CASE NO. 08-15

Memorandum

SUBJECT: Final Report - ZC #08-15 (Friendship Shopping Center, 3336 Wisconsin Avenue, NW Consolidated PUD and Related Map Amendment Square 1920, Lot 831; Square 1920-N, Lots 1 and 2)

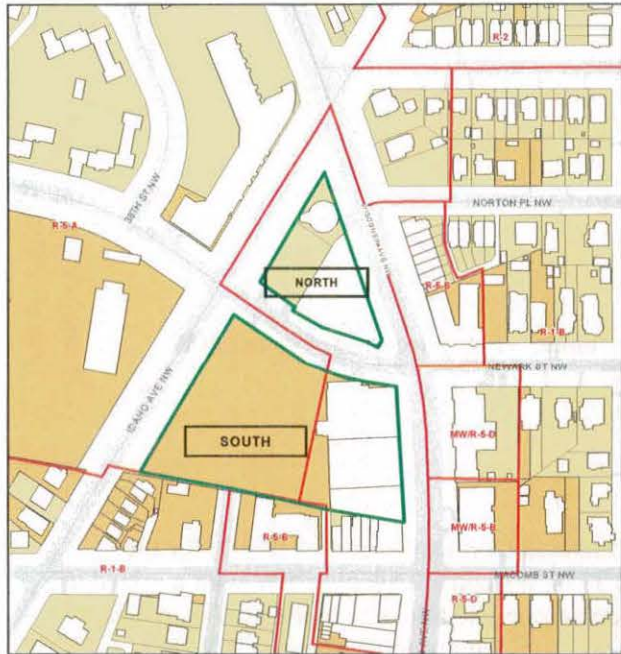
Since the submission of the application, the plan has been revised based on comments and feedback from the Office of Planning (OP), the District Department of Transportation (DDOT) and the community. The revised Site Plan shows the entrance to the loading area from Idaho Avenue, NW being relocated so as to provide a larger open space area and buffer between the loading area and the adjacent single-family detached residences. Secondly, the façade and architectural details of the mixed use buildings have been changed.
